CERTIFICATE OF APPROPRIATENESS

I. CASE NUMBER(S): P14-0360

- 1) **Proposal:** Proposed Certificate of Appropriateness for construction of a new 1,400 square foot, single story single family residence with a 441 square foot detached garage within the Palm Heights Historic District on a vacant, formerly developed lot within the R-1-7000-CR (Single Family Residential, Cultural Resources Overlay) Zone and Palm Heights Historic District.
- 2) **Location:** 4570 Sunnyside Drive, located 480 feet west of Palm Avenue.
- 3) **Applicant:** Cleve Stevens, Riverside Housing Development Corporation
3985 University Avenue
Riverside, CA 92501
- 4) **Case Planner:** Teri Delcamp, Historic Preservation Senior Planner
(951) 826-2117
tdelcamp@riversideca.gov

A2

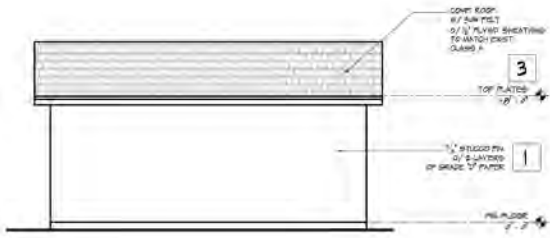
- d. The sets of paired windows on the north (front) elevation, and the first two single hung windows on the west (side) elevation are publicly visible within the Historic District, and shall be wood sash. All other windows may be vinyl or similar quality alternative material.

- e. *Advisory:* The applicant should consider changing the paired windows on the front elevation to be multi (six or eight lights)-over-single pane.
 - f. Unless otherwise approved by CHB staff, the driveway shall be gray concrete with historically appropriate scoring, without any modern finishes or added colors.

A6

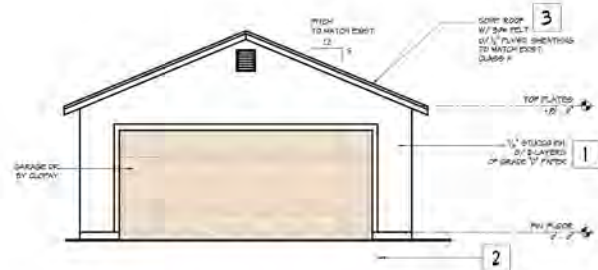
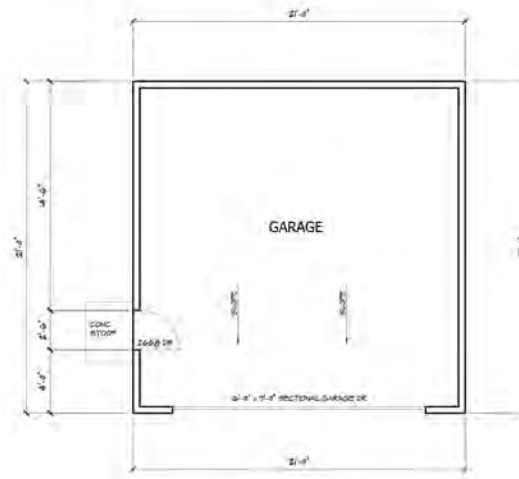
- h. The garage exterior materials, details and colors shall match those of the new home. The garage door shall be of a color or painted to match the approved paint scheme.
